# MIAMI BEACH

### Staff Report & Recommendation

### Design Review Board

SUBJECT: DRB18-0331  
**1030 West 47<sup>th</sup> Street**

1941 Aerial

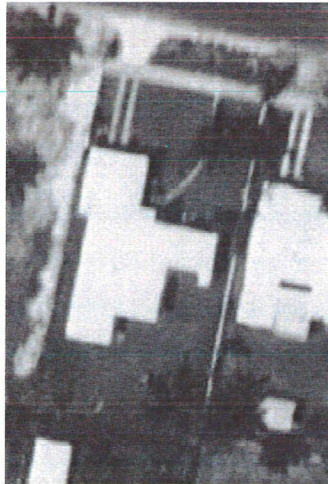
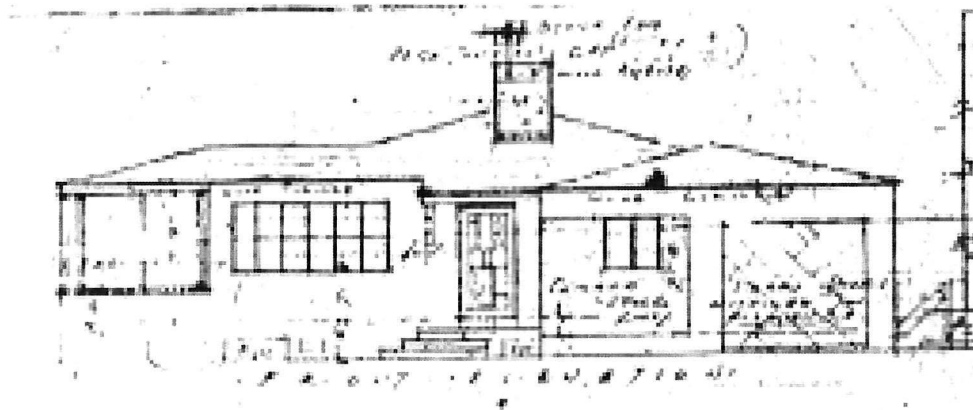
The aerial photograph below shows the home in 1941 as constructed compared with the 2018 aerial which depicts the exterior alterations that occurred to the property in 1949 (dining room and remodeling interior garage changes) and the 1971 introduction of a rear “porch” and front carport.

1941 Original Façade

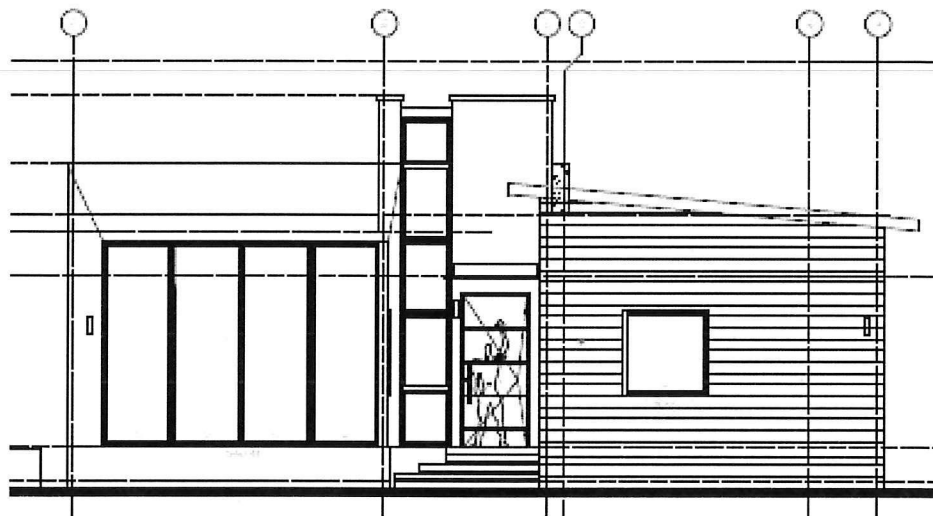
All of the original architectural features of the modest Mediterranean Revival w/ Art Deco Influence home will be removed in order to transform the basic form of the building into a sharp, one-story residence contemporary in style. The sole remaining element will be the basic tripartite division of the façade and form, as well as the central entry element as a higher more prominent articulation.

A substantial amount of the residence will be demolished in order to construct new one-story additions at various locations on the site and the style will be “modernized”. Because staff believes that the magnitude of the construction exceeds the level that can be approved administratively for a pre-1942 home, review and approval of the Board is required. As the new additions have been designed in a manner that is consistent with the existing architectural scale of the home, as well as the fact that the height, unit size and lot coverage is well within the threshold limits of the City Code for one-story residences, staff is supportive of the additions and recommends approval as noted below. Substantial renovations and investments have been made both to the interior and exterior of the building and the owner of the property no longer wishes to maintain the exterior style of the architecture. Staff has no concerns with the approval of the proposed changes.
